RE: Planning Application 21/00922/OUT
Land West of Foxden Way Great Bourton

Re: Application 21/00922/out

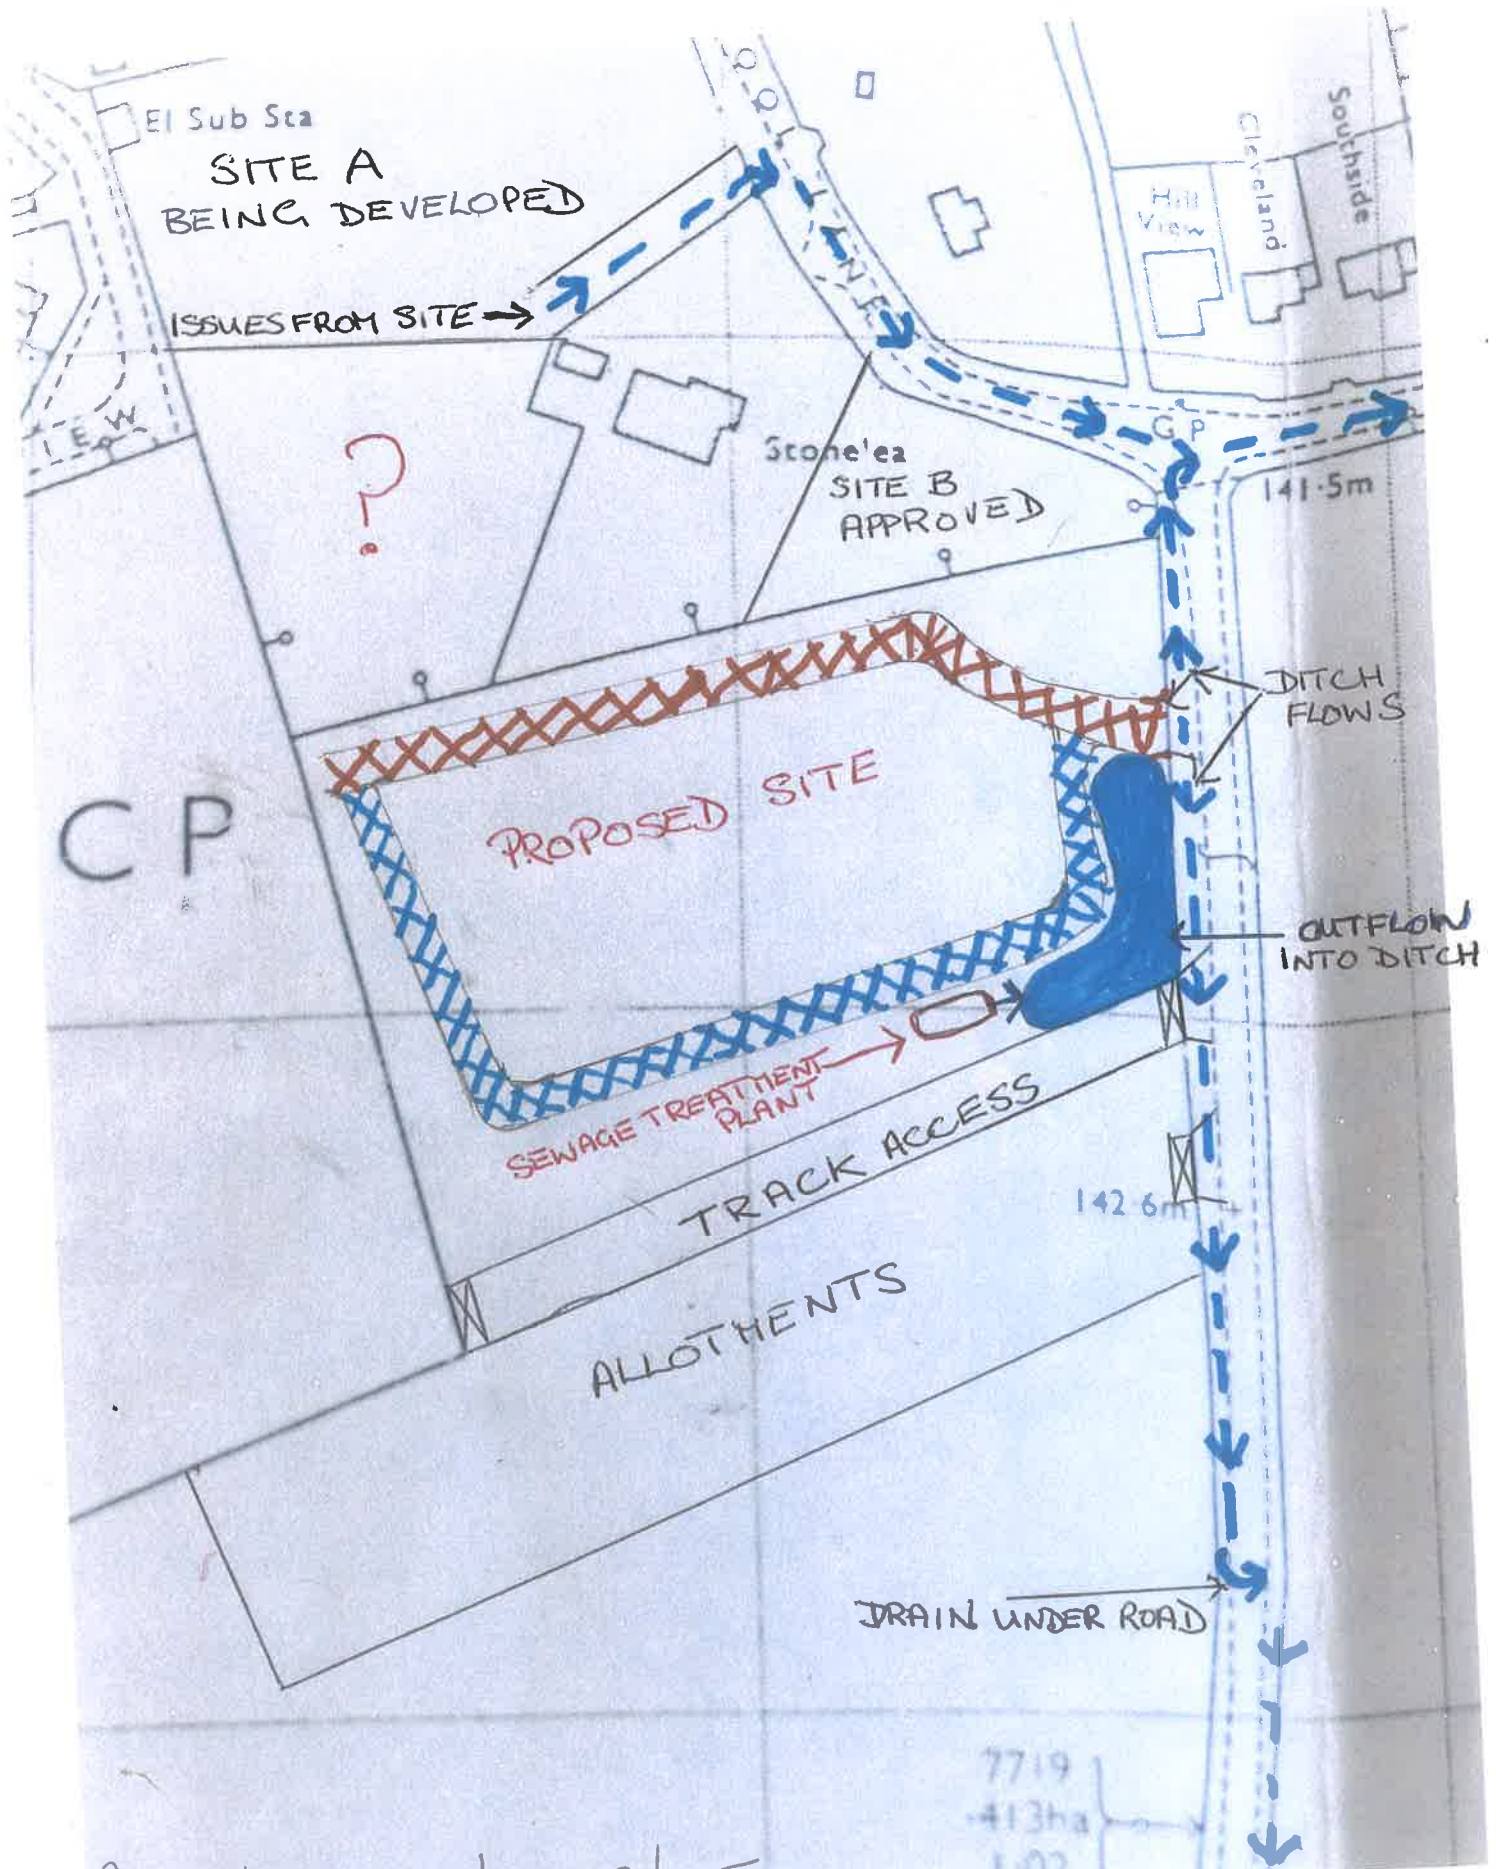
I am very concerned with the drainage issues on this site and where they might be directed to. We already have problems with surface water from Foxden Way, School Lane, and muddy flows exiting from the access to Site A on the enclosed plan. They flow in vast quantities down Crow Lane and then down the Cropredy road causing flooding at the bottom of the hill. Last year Cropredy School had to be closed for two days because these flows from Great Bourton caused the road by the school to be in flood. It would be unwise to let more water from the proposed site to add to this problem. I have met with OCC Highways regarding the drainage problems that already exist in Crow Lane and as yet they have not been resolved.

I note that the Agent states the site is impermeable as it has a clay substrata and this is correct. I note that a permeable road is highlighted marked Blue on part of the plan but no mention is made of the access road marked Brown on my plan. When this substrata is clay even a permeable road will have to be piped to the ditch. Much of the site will naturally drain to Crow Lane causing even more flooding.

There is no easy access to the main sewer and there are now strict conditions which in many cases do not allow on site sewer treatment into water courses. This site is not permeable and a soakaway system is not possible especially when it is to serve a small estate. There would need to be significant ditch re profiling to where flows would have to go under the road and from there more ditch work across the top of the Cemetery to Mill Lane. This would all need regular maintenance. We already have flooding at the bottom of Mill Lane where ditch flows are restricted by the Railway culvert that already causes flooding to both mine and my neighbour's land. There is no doubt that these flows would have an unpleasant aroma and with the added flooding risk this application should be refused.
